# SERVICE BULLETIN

## Software Update for Engine Control Unit (ECU) on ROTAX® Engine Type 915 i (Series)

### MANDATORY

Software Update for Engine Control Unit (ECU) on ROTAX® Engine Type 915 i (Series).

Fig. 1  
ECU

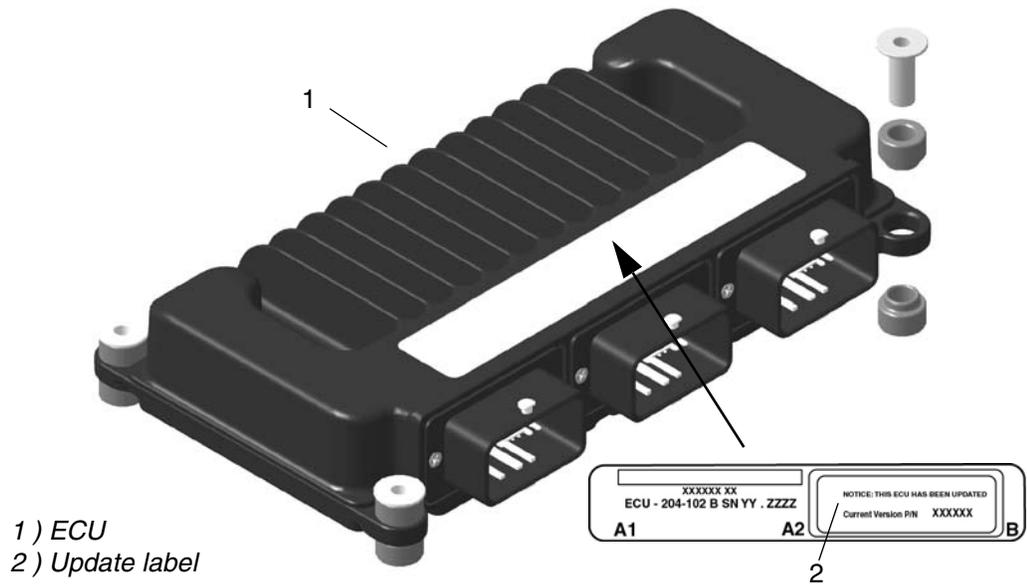
Label the ECU at position 2 (Fig. 1) with the ECU Update Label part no. 898804 or 898808, depending on engine type.
